MAMMOTH CROSSING PROJECT

April 17, 2009

**MAMMOTH CROSSING PROJECT
FINAL ENVIRONMENTAL IMPACT REPORT**

Figure II-2
View 11: Minaret Road Adjacent to Fireside
Condominiums Looking South (Before)

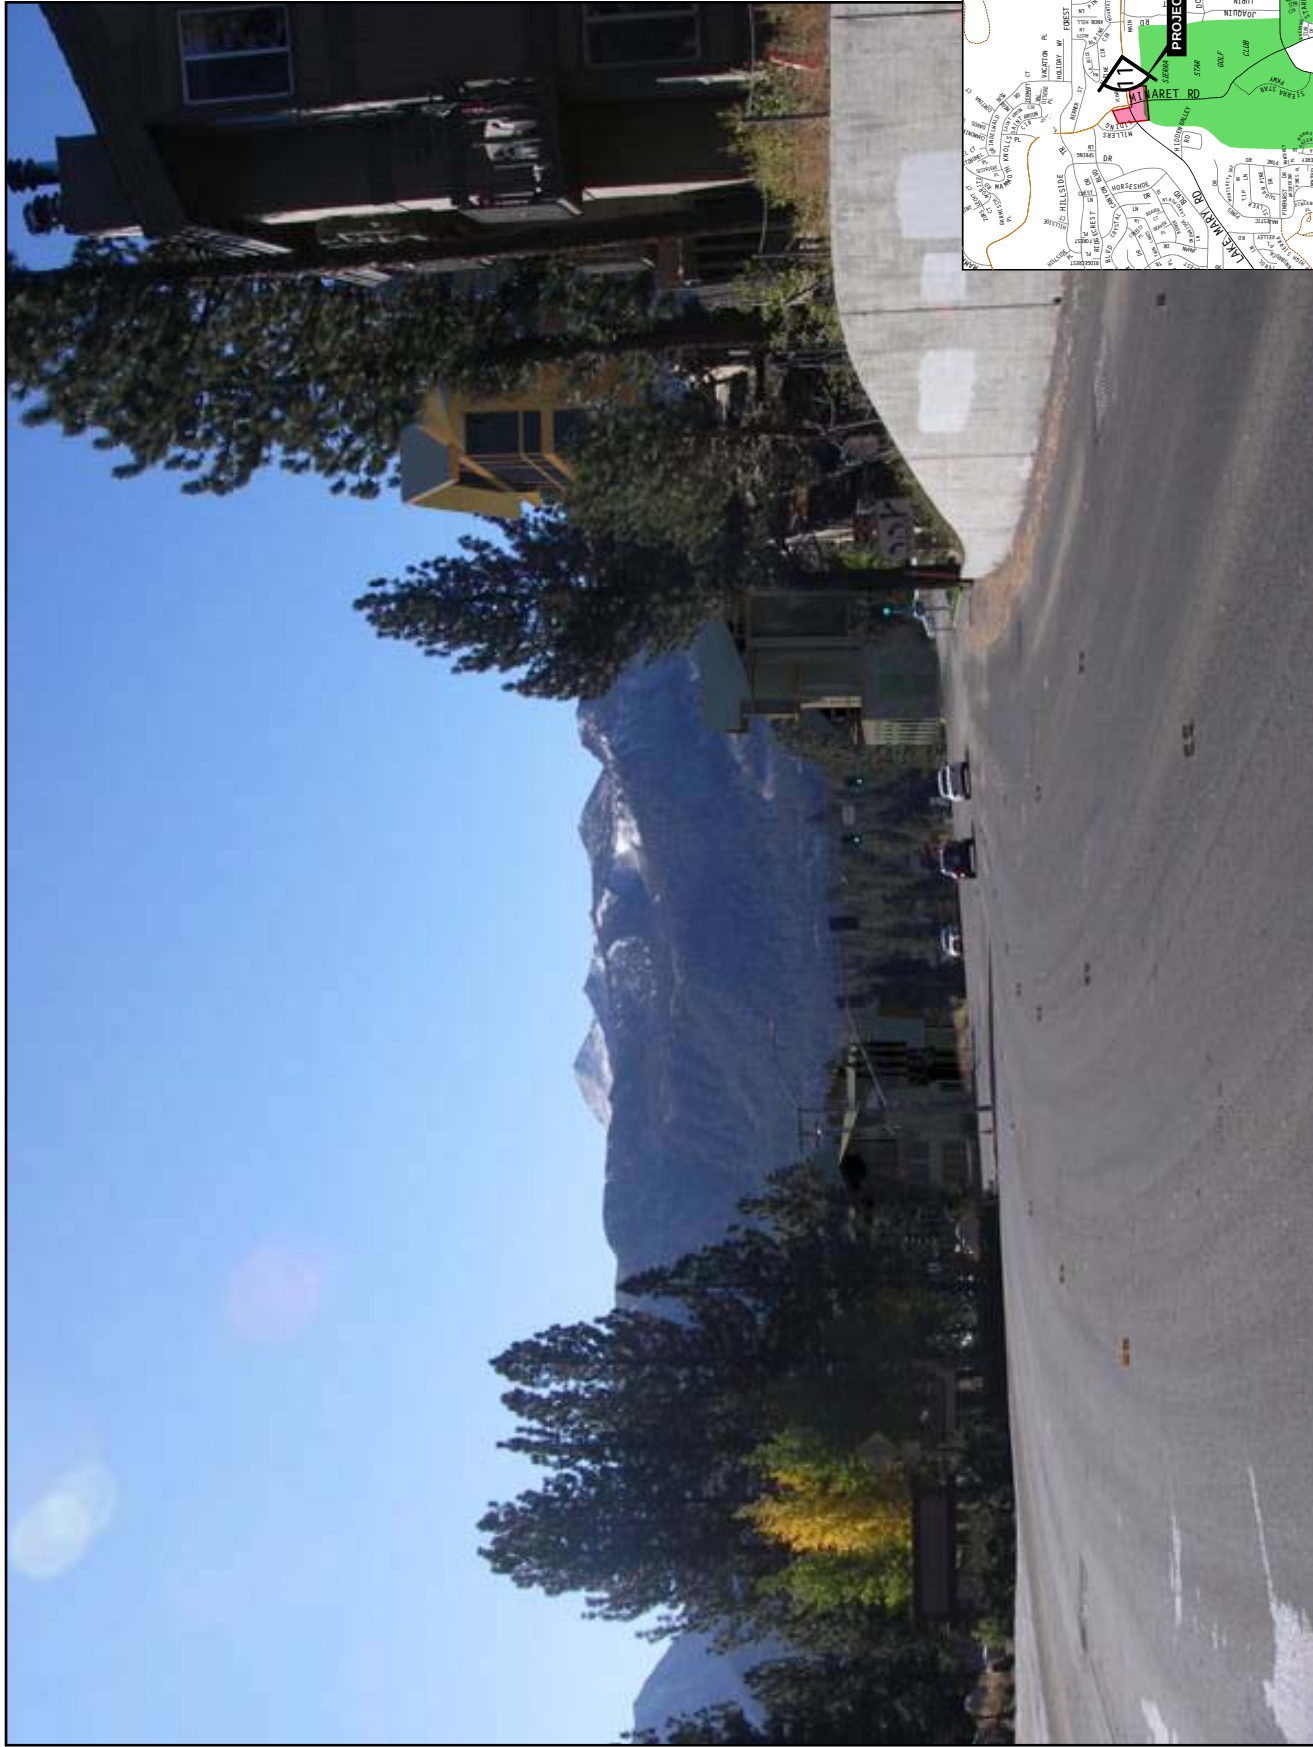
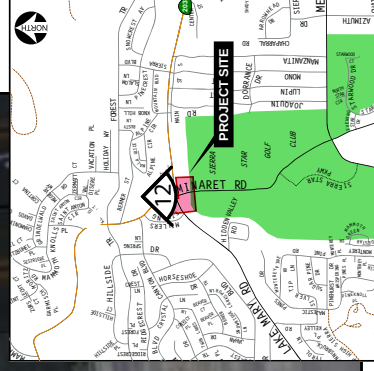
View 11 is located on Minaret Road adjacent to the Fireside Condominiums looking south in the direction of the Project site. Public views from this area include the Sherwin Range. As shown on Figure II-2, the existing buildings on Site 1 and Site 3 are visible from this viewpoint and do not block views of the Sherwin Range. Figure II-3 illustrates that the proposed development on all three Project sites would be visible from this viewpoint. However, due to the curves, natural topography, and trees along Minaret Road the proposed development after Project build-out would not substantially block views of a scenic vista (i.e., Sherwin Range) from View 11. Therefore, public views of scenic vistas from View 11 would not be significantly altered with the development of the Project and impacts would be ***less than significant***.

Figure II-2
Aerial Photograph

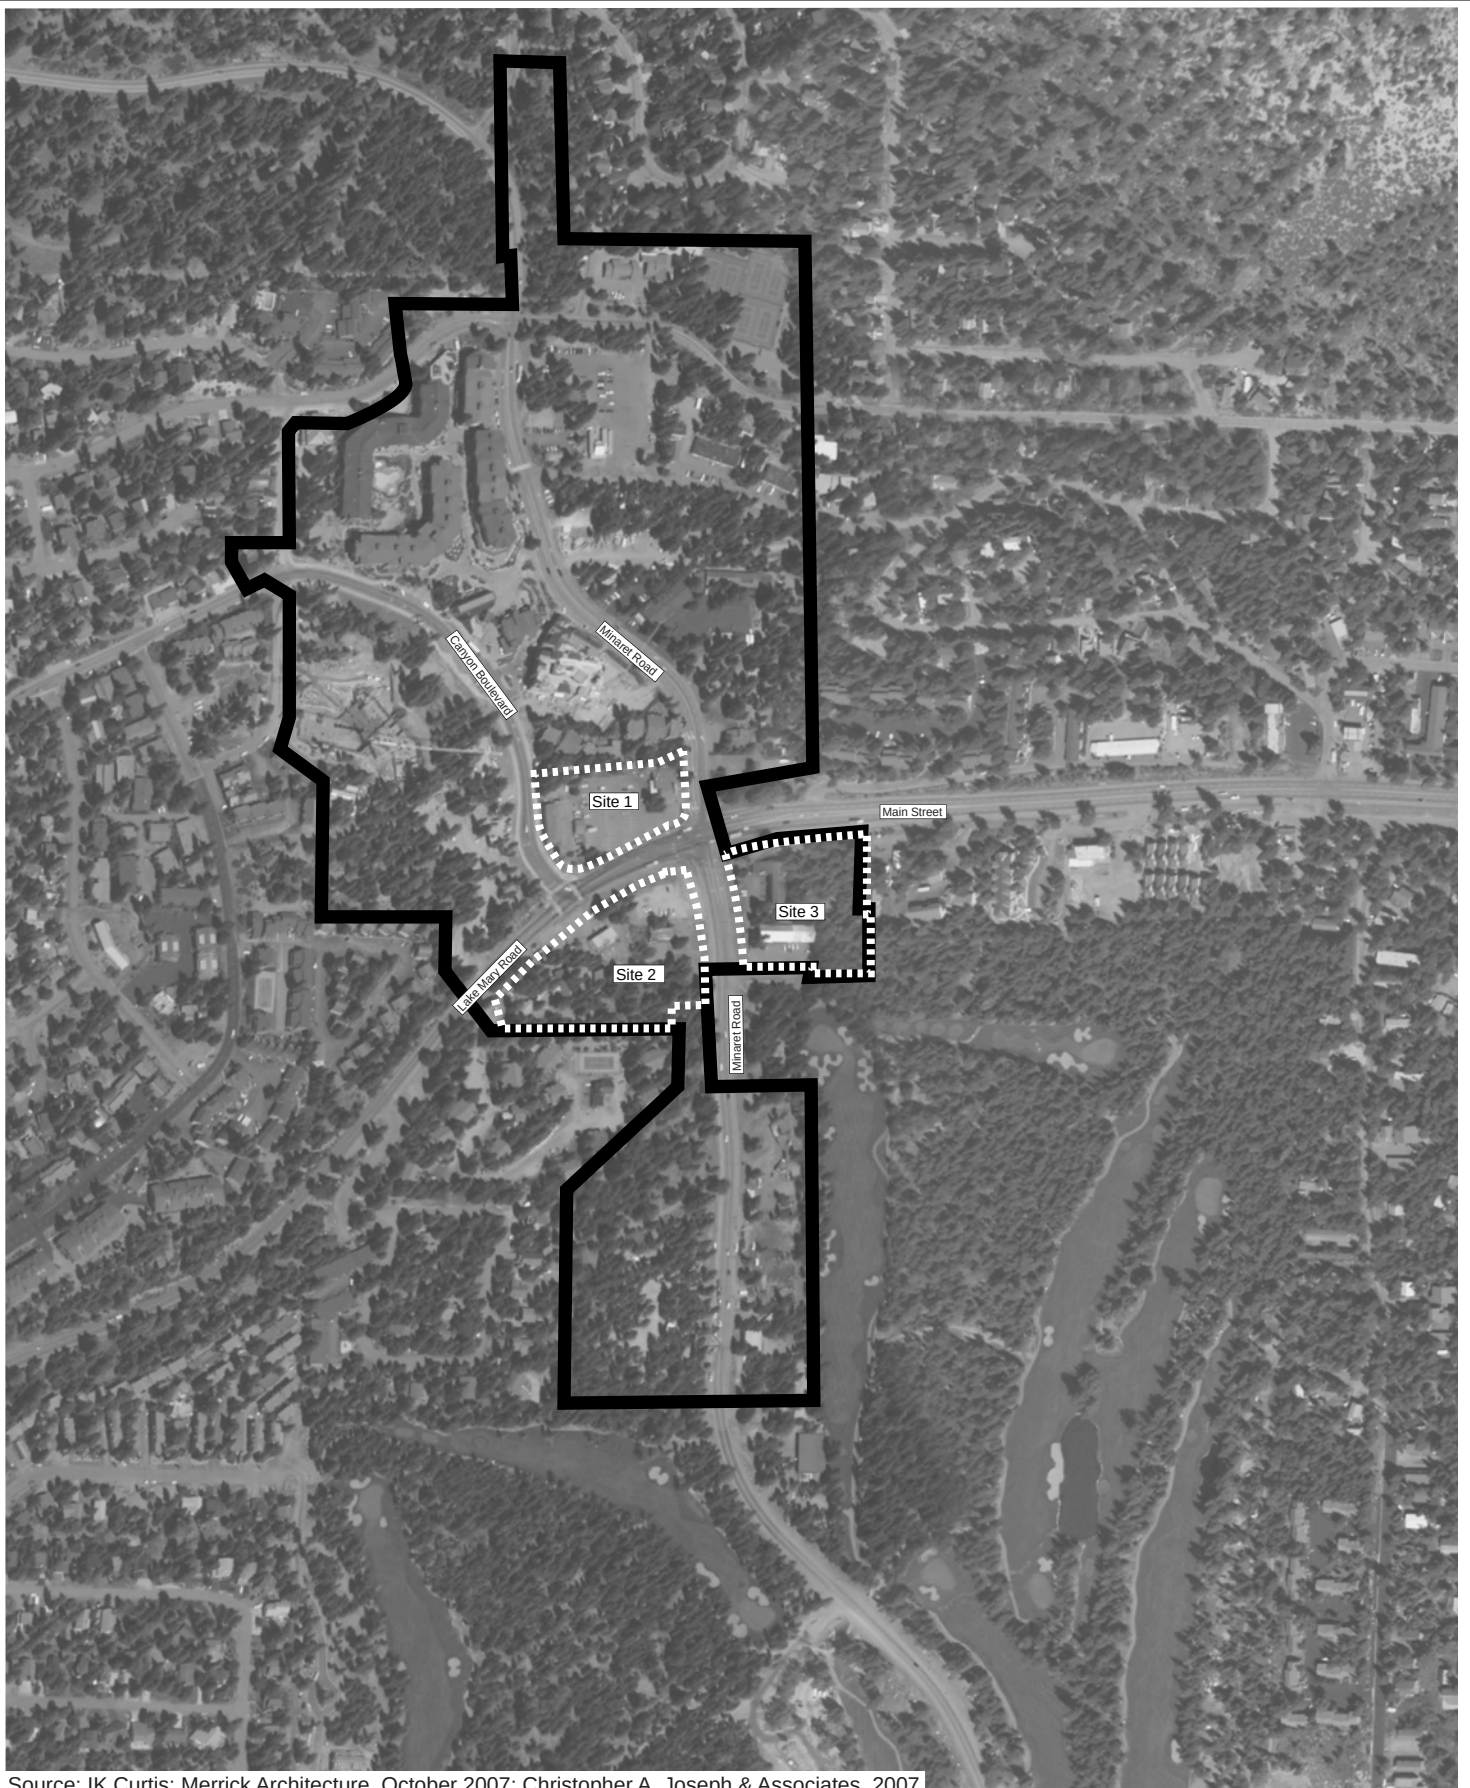
In response to Town comment, Figure II-2, Aerial Photograph, on page II-4 of the Draft EIR has been revised to reflect Project Sites 1, 2 and 3. Project Site 4 was removed from the figure. The corrected figure is included in this Final EIR.

Mammoth Lakes Zoning

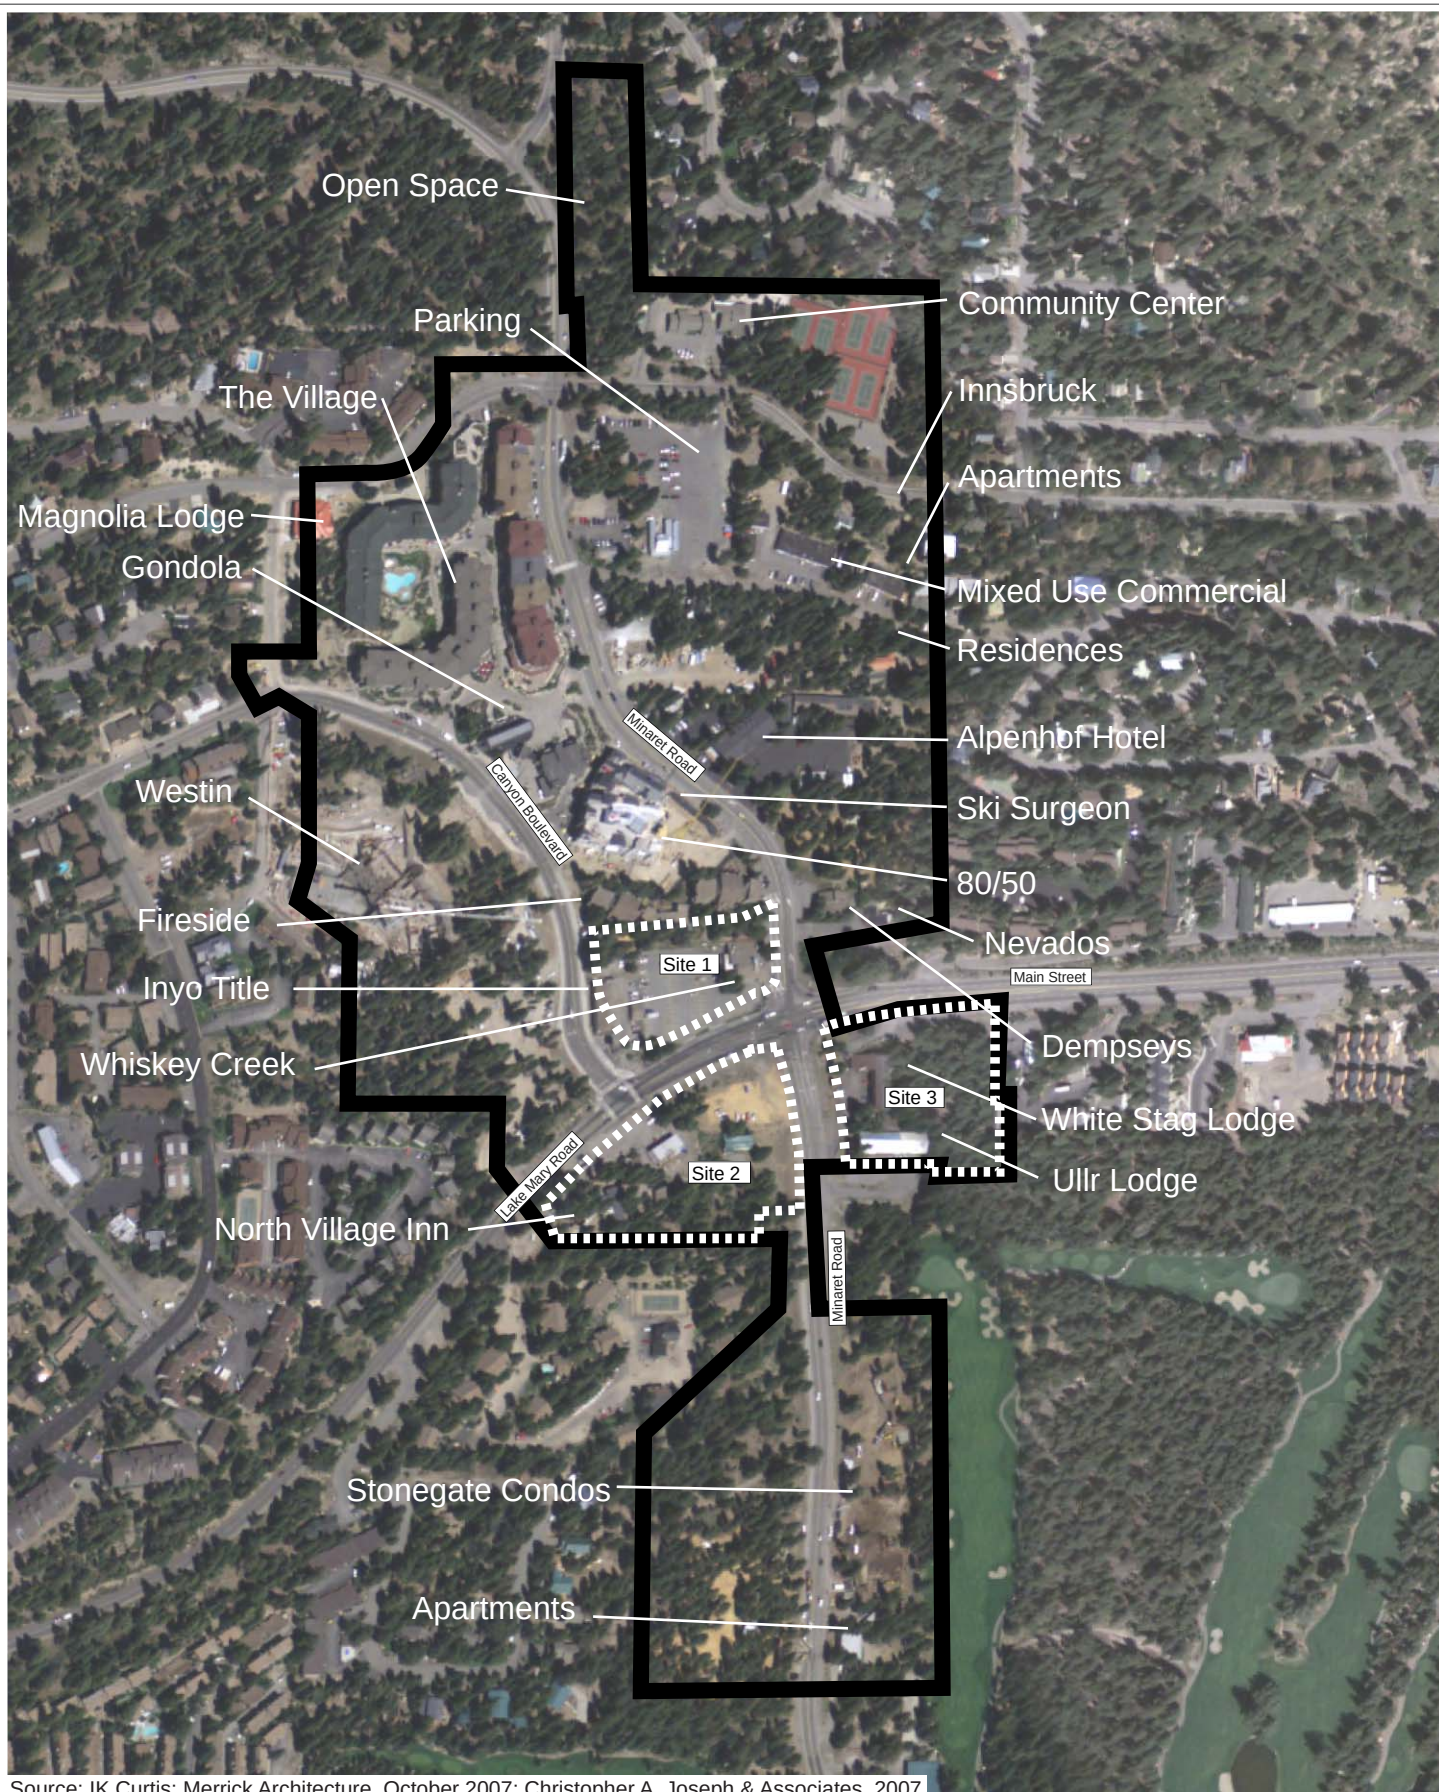
In response to Town comment, Figure II-4, Zoning Map, on page II-6 of the Draft EIR has been revised to reflect Project Sites 1, 2 and 3. Project Site 4 was removed from the figure. The corrected figure is included in this Final EIR.

Figure II-6
Views of Project Site 1
Views 1-3

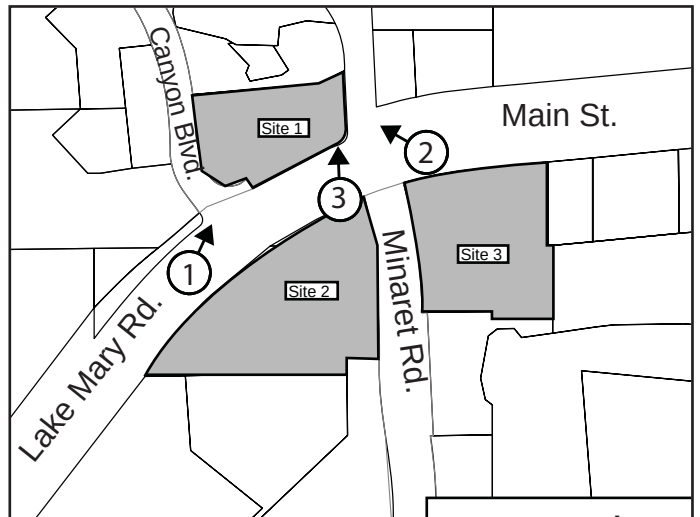
In response to Town comment, Figure II-6, Views of Project Site 1, Views 1-3, on page II-9 of the Draft EIR has been revised to reflect Project Sites 1, 2 and 3. Project Site 4 was removed from the map included in the figure. The corrected figure is included in this Final EIR.

Figure II-7
Views of Project Site 2
Views 4-6

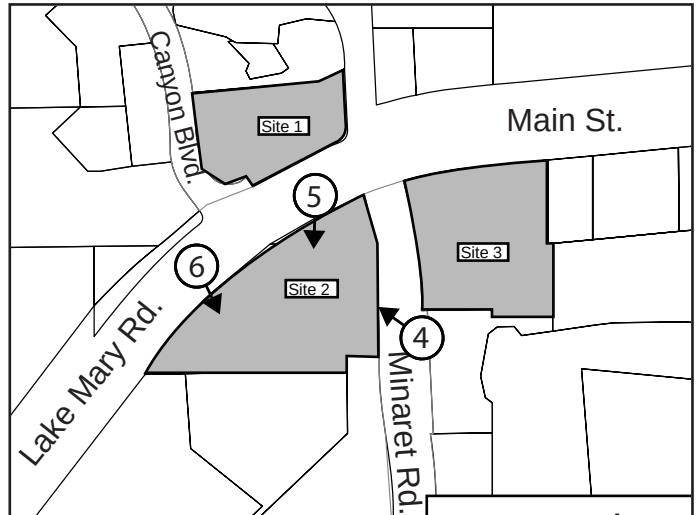
In response to Town comment, Figure II-7, Views of Project Site 2, Views 4-6, on page II-10 of the Draft EIR has been revised to reflect Project Sites 1, 2 and 3. Project Site 4 was removed from the map included in the figure. The corrected figure is included in this Final EIR.

Figure II-8
Views of Project Site 3
Views 7-9

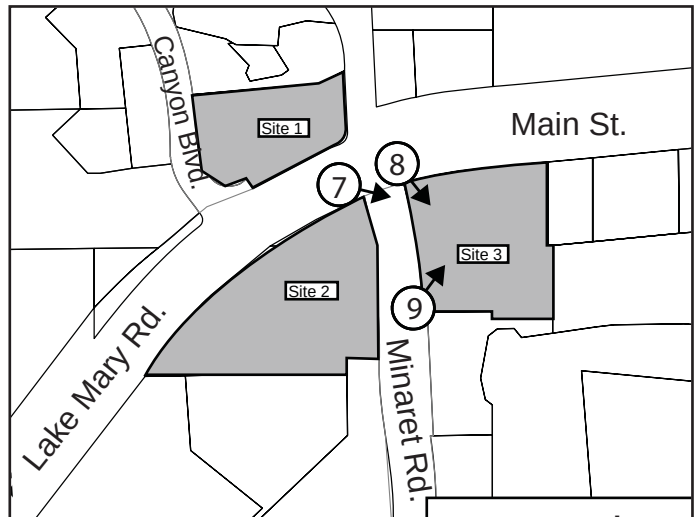
In response to Town comment, Figure II-8, Views of Project Site 3, Views 7-9, on page II-11 of the Draft EIR has been revised to reflect Project Sites 1, 2 and 3. Project Site 4 was removed from the map included in the figure. The corrected figure is included in this Final EIR.

Figure II-9
Views of Surrounding Land Uses
Views 1-3

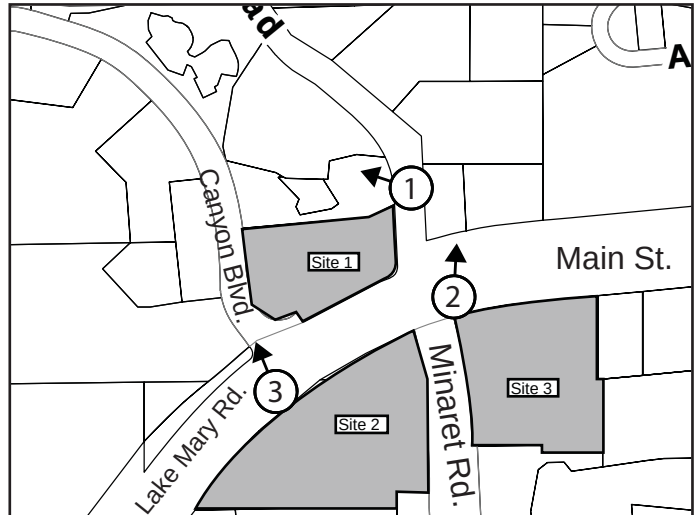
In response to Town comment, Figure II-9, Views of Surrounding Land Uses, Views 1-3, on page II-12 of the Draft EIR has been revised to reflect Project Sites 1, 2 and 3. Project Site 4 was removed from the map included in the figure. The corrected figure is included in this Final EIR.

Figure II-10
Views of Surrounding Land Uses
Views 4-6

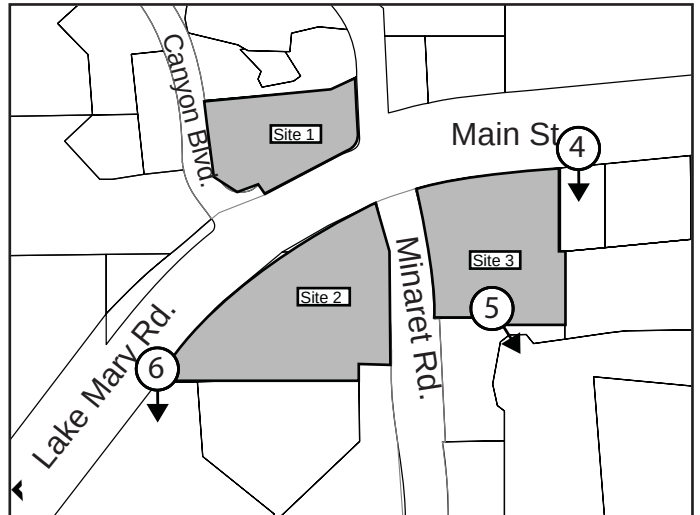
In response to Town comment, Figure II-10, Views of Surrounding Land Uses, Views 4-6, on page II-13 of the Draft EIR has been revised to reflect Project Sites 1, 2 and 3. Project Site 4 was removed from the map included in the figure. The corrected figure is included in this Final EIR.
